ADDENDUM NO. 2

HELENA FIRE STATION #3

PROJECT: Helena Fire Station #3
Helena, Montana

ARCHITECT: DOWLING Architects
734 North Last Chance Gulch
Helena, MT 59601
406-457-5470

RCP LEGEND REVISION

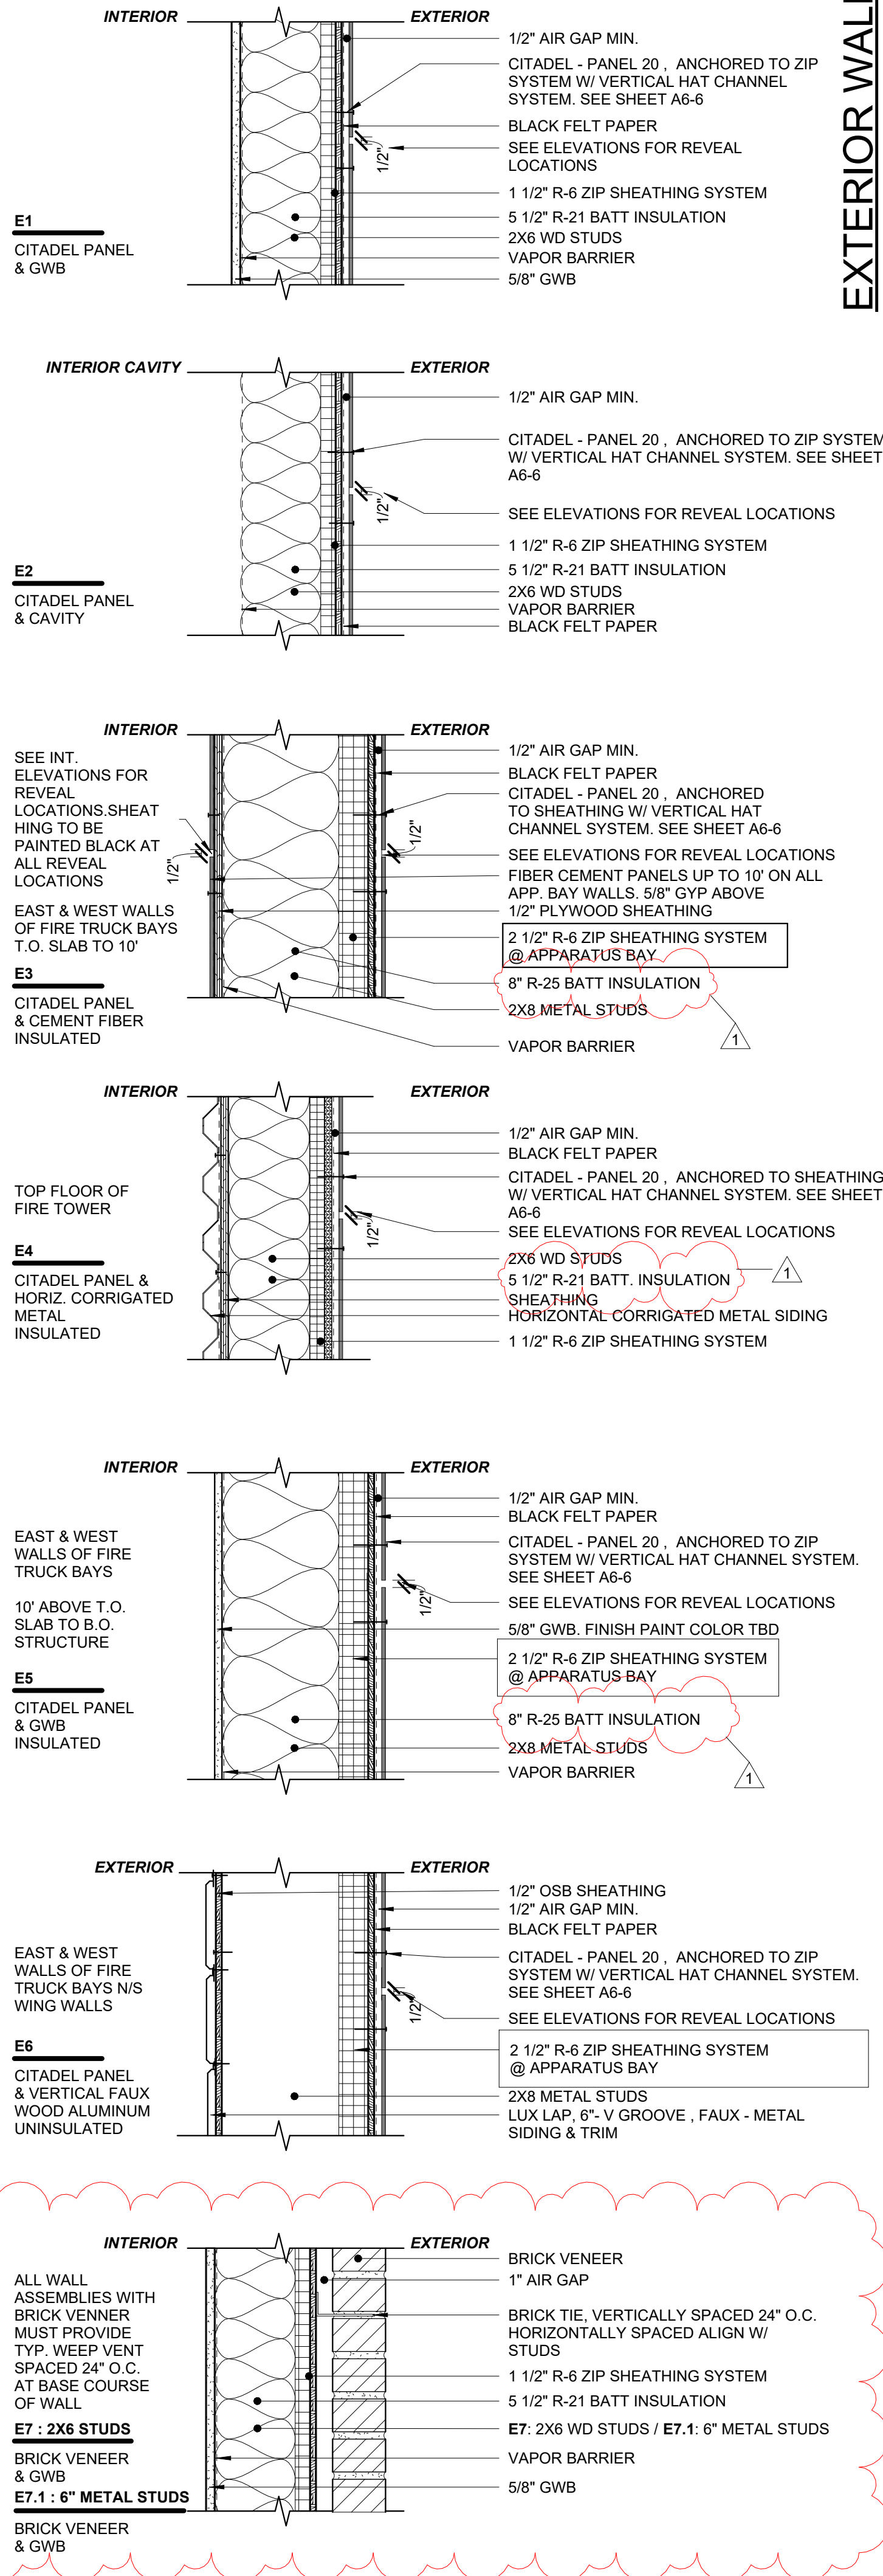
- **ATTN-6** – Clarifies RCP Legend in regards to ACT tile
- **Sheet S1-2 First Floor Framing Plan**– Added call-outs to denote interior walls that are framed using 2x4 studs

Answer: Acoustical Ceiling, Basis of Design. Armstrong Fine Fissured Second Look #1766. 4" for the edge detail.
- Question:** Specification section 10 1100; Fire Protection Specialties. Describes fire extinguishers. I can't find where the Fire Extinguishers/Locations are called out in the plans?

A1-2

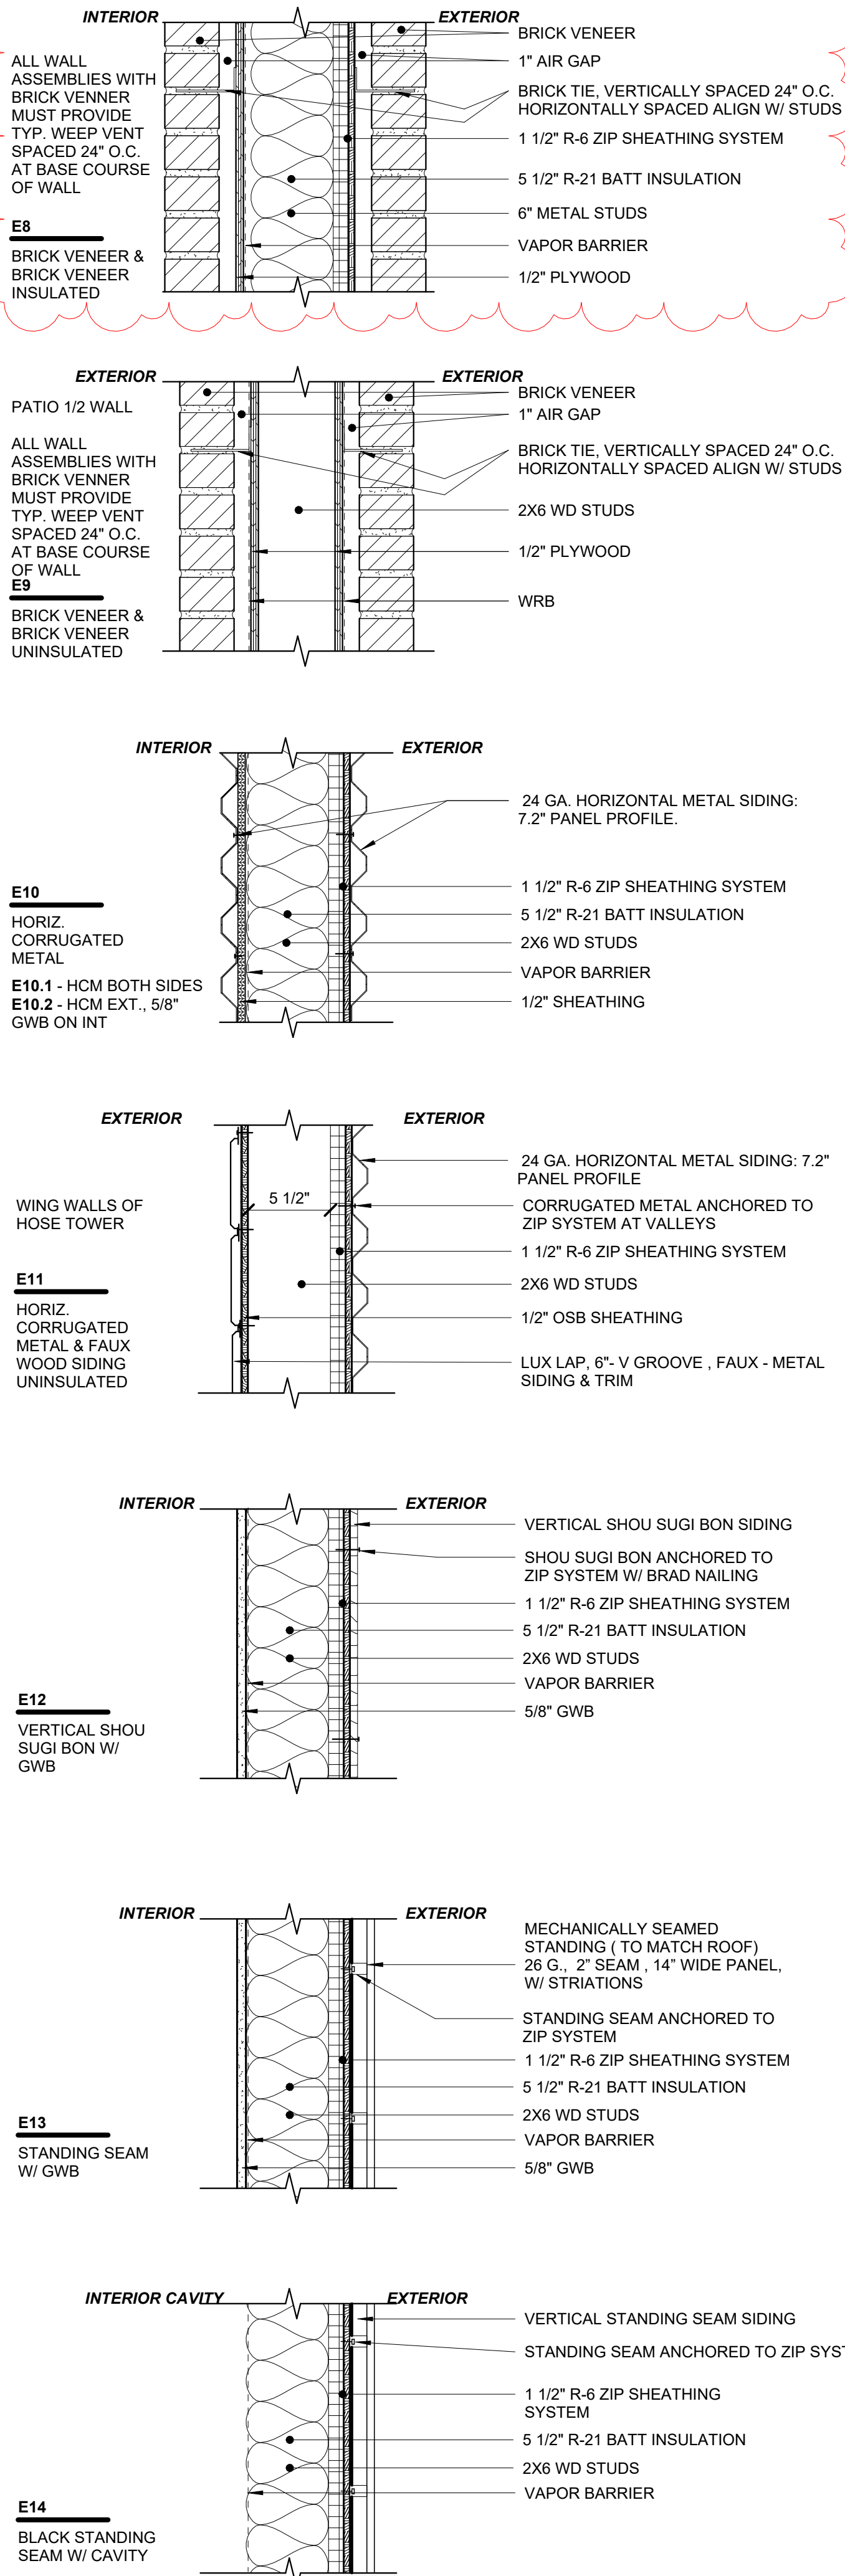
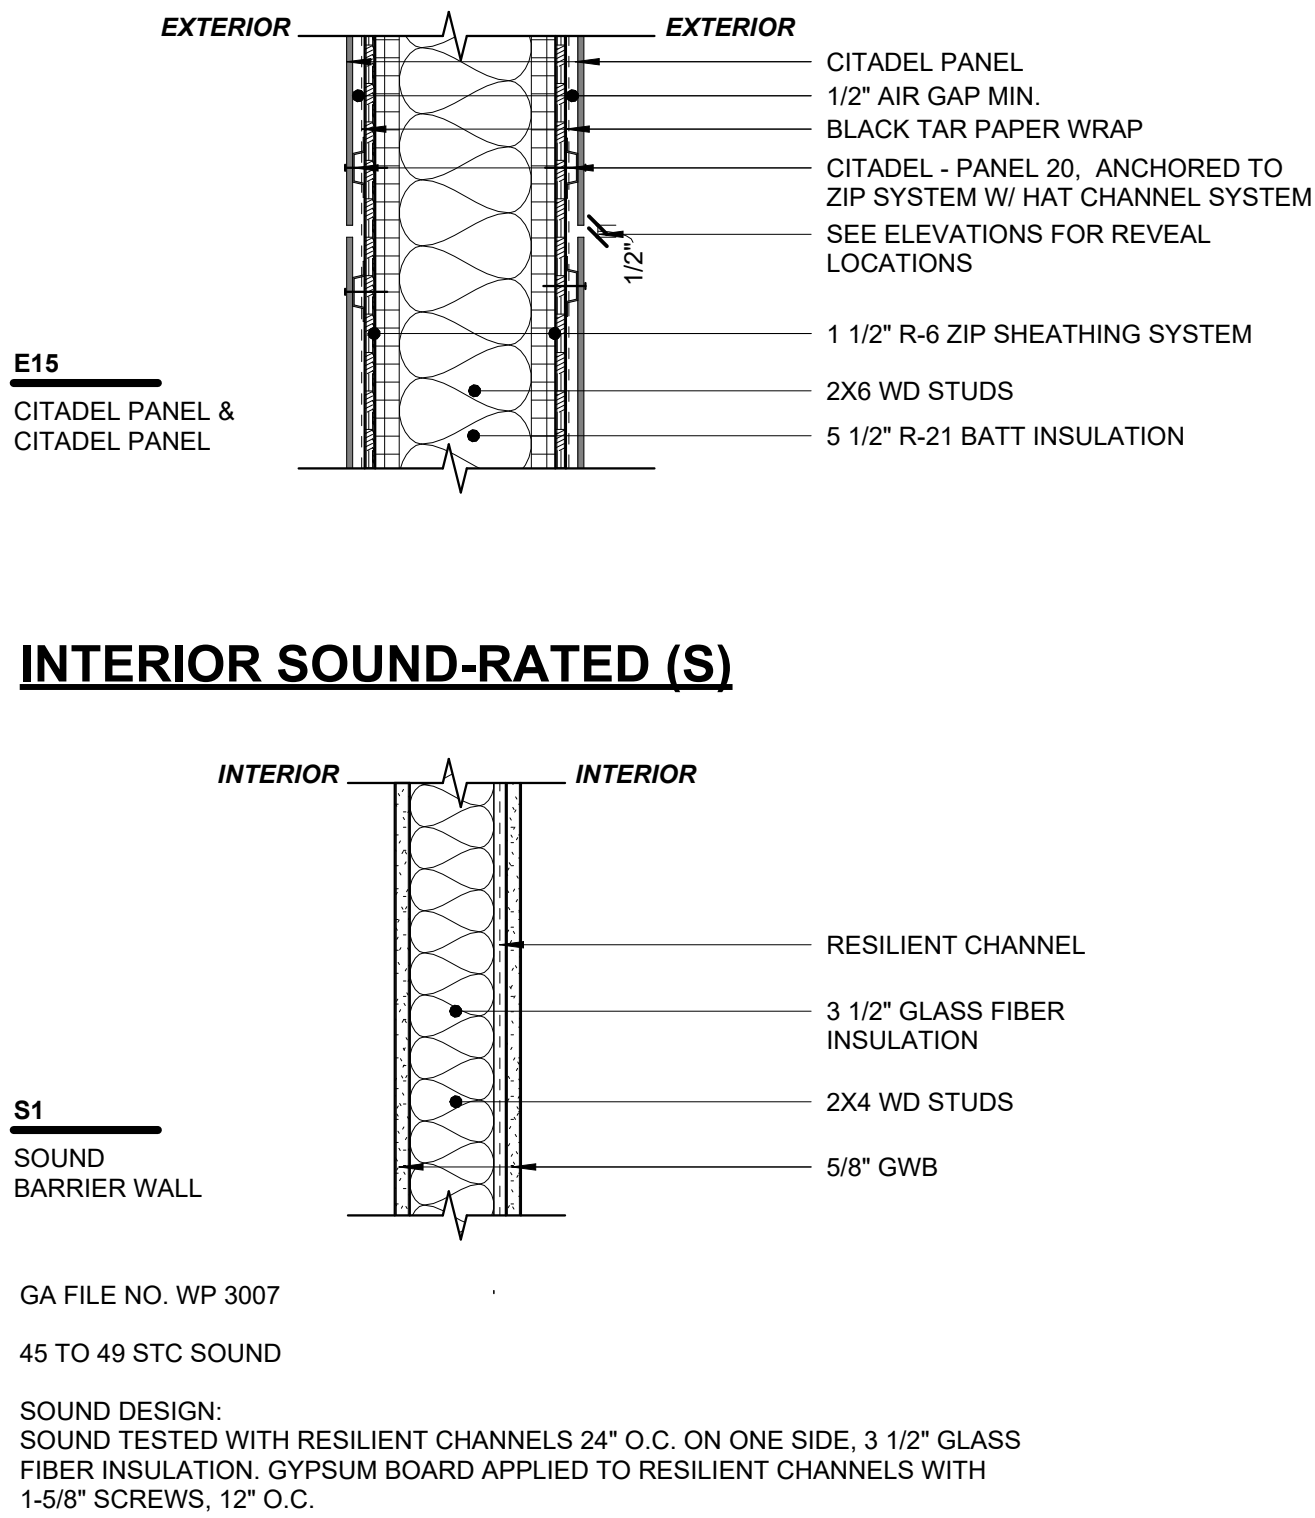
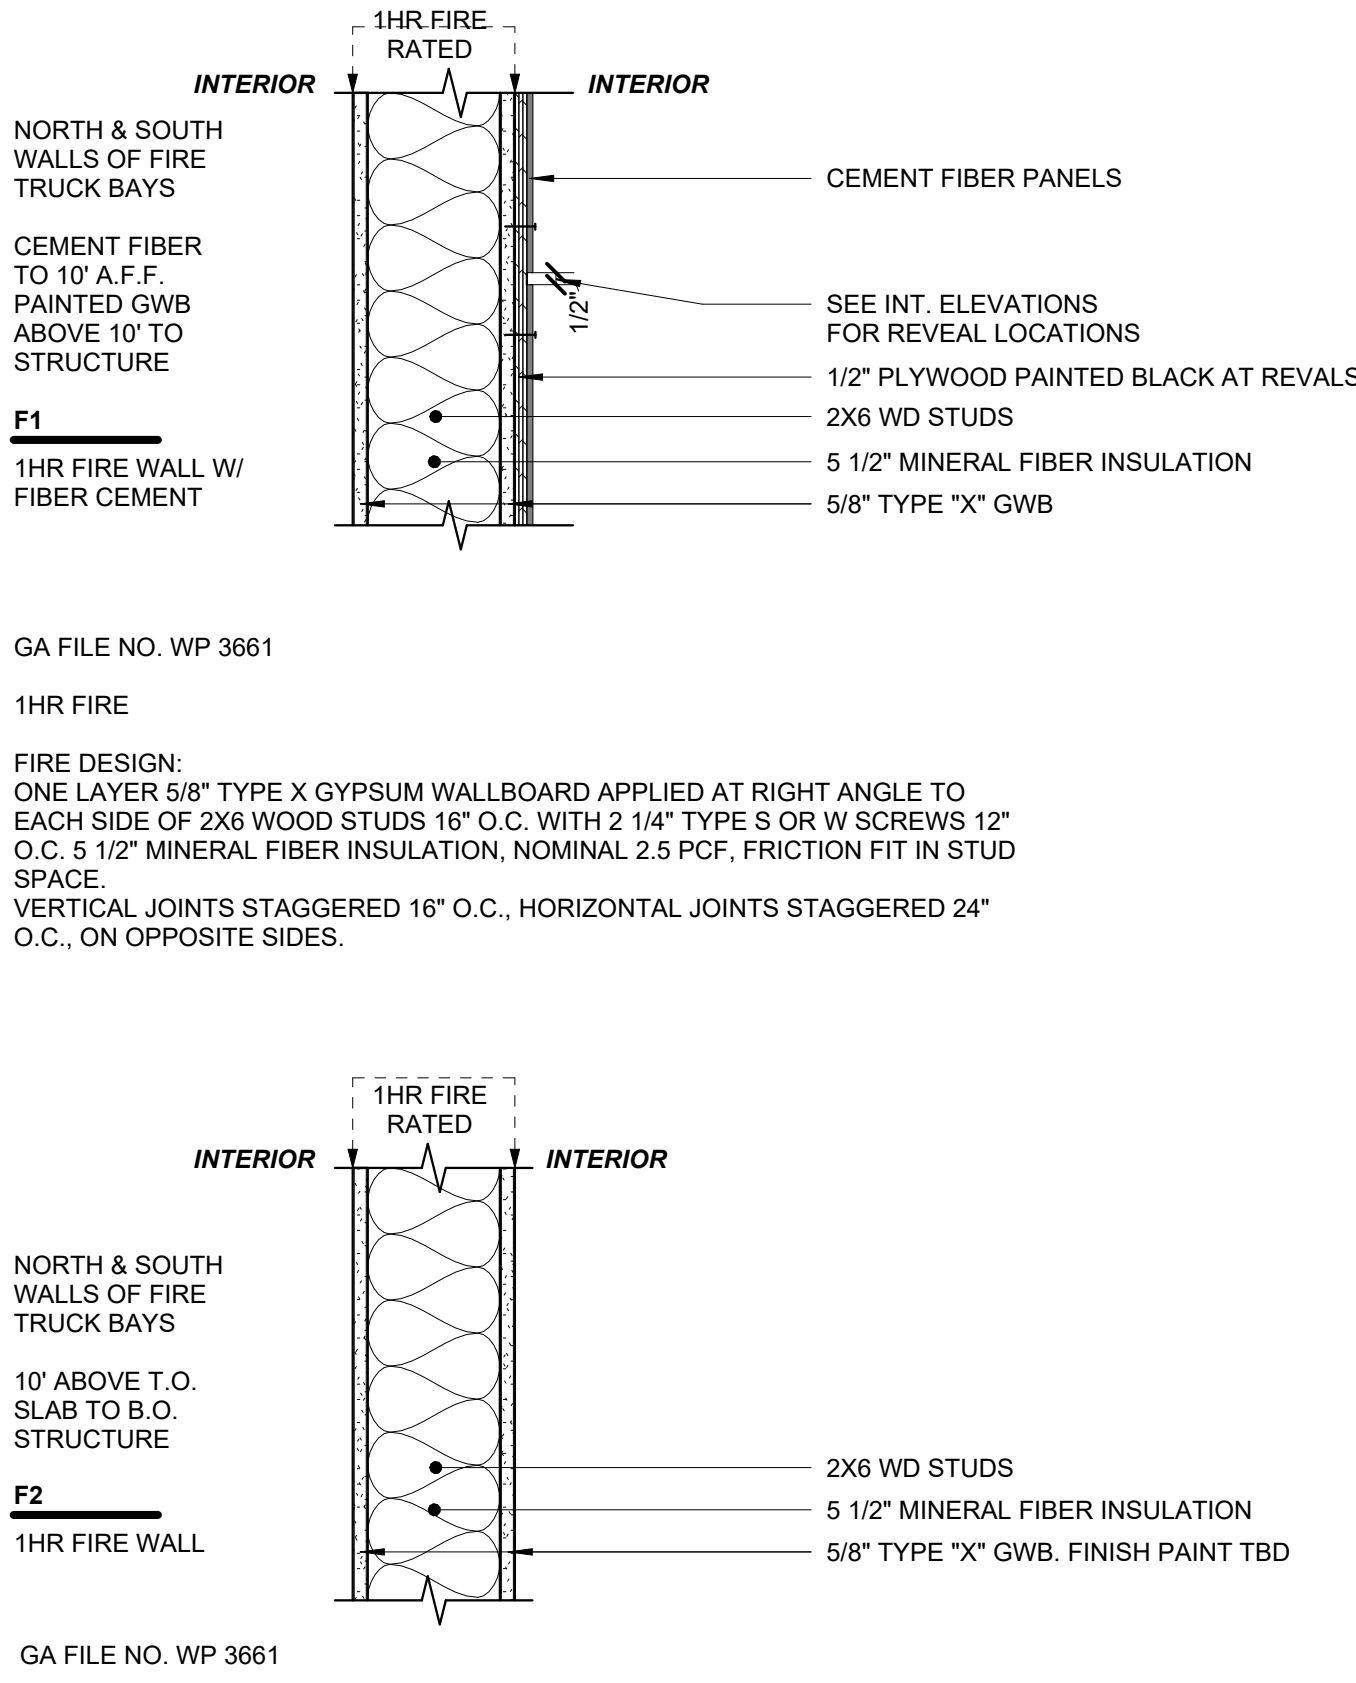
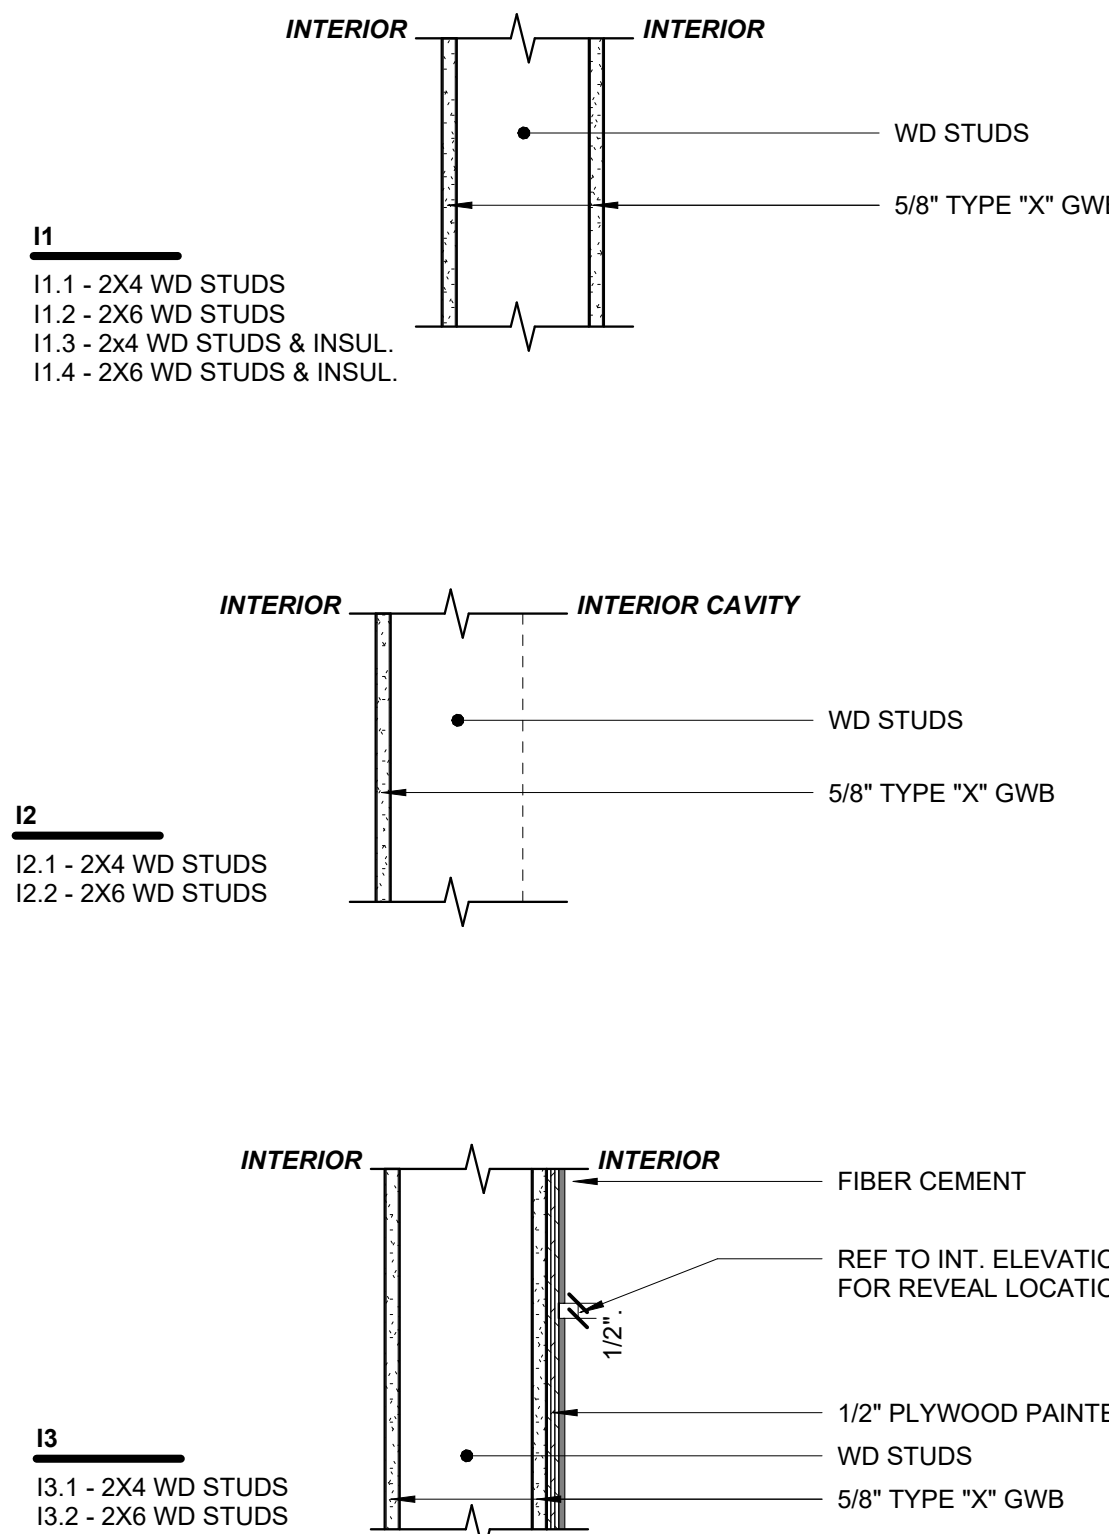
- **Sheet A1-2 Wall Assemblies-** Changes to wall assemblies E7 & E8. E7 has been changed to include a E7.1 assembly variation that will be 6" metal stud framing. Assembly E8 has changed from 2x6 wood framing to 6" metal stud framing. View revised sheet A3-2 for the wall locations affected by these changes.
